**To:** Kristopher Byrd, Well Construction Manager  
**From:** Tommy Laird, Well Construction Program Coordinator  
**Subject:** Review of Water Right Application G-19187  
**Date:** February 27, 2024

Application # G- 19187

TO: Water Rights Section Date October 24, 2023  
 FROM: Groundwater Section Gabriela Ferreira / Dennis Orlowski  
 Reviewer's Name  
 SUBJECT: Application G- 19187 Supersedes review of \_\_\_\_\_  
 Date of Review(s)

**Stream Depletion (Hunt) Model Analysis**

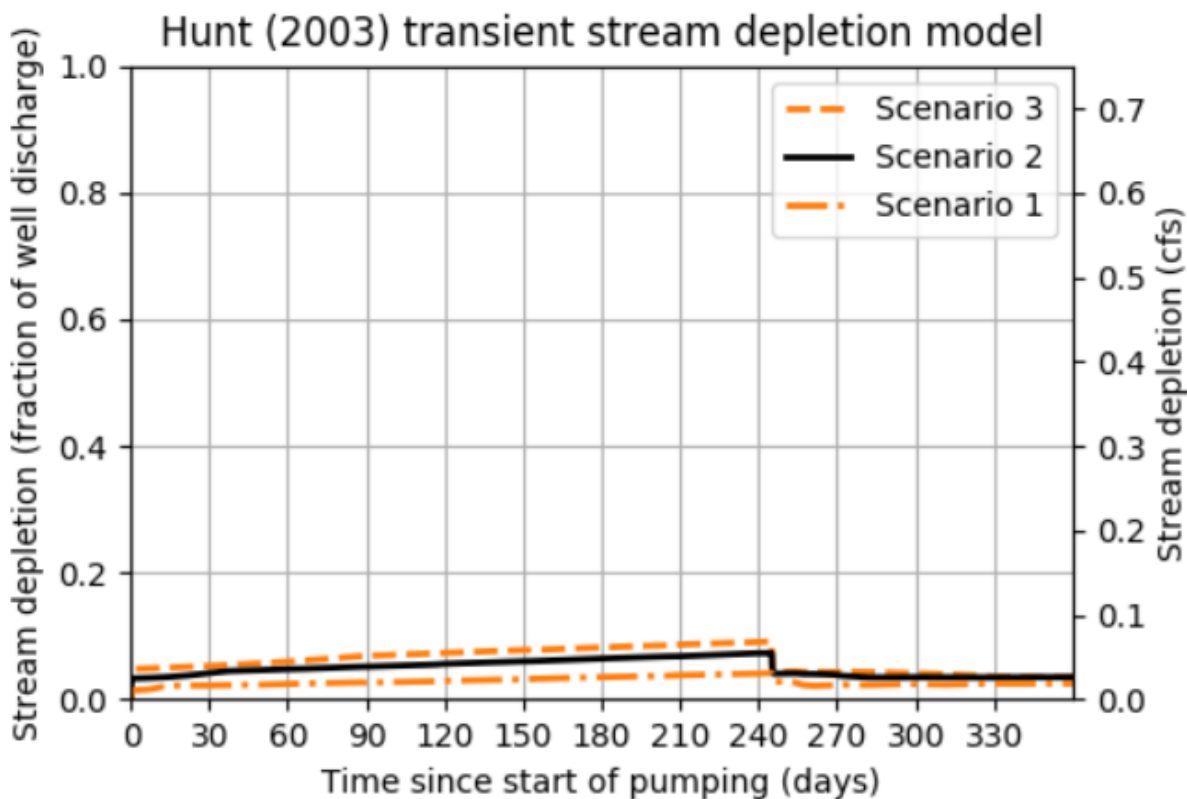
**Comments:** C3a: The Hunt 2003 analytical stream depletion model was used to estimate 30-day interference at SW 1 (Unnamed Tributary to Parrott Creek – West ) caused by pumping Well 2, the nearest of the proposed POAs, to estimate the maximum anticipated interference, based on proximity and similar hydrologic conditions. Model parameters are derived from nearby pumping tests and published values (Freeze and Cherry, 1979). Model results indicate that interference is expected to be less than 25% of the maximum allocated pumping rate at 30 days. The model was not applied to the other scenarios because they are farther from respective streams, and thus, given a similar hydrogeologic setting, the estimated 30-day stream depletion percentages would be even less than that estimated for the Well 2/SW 1 scenario
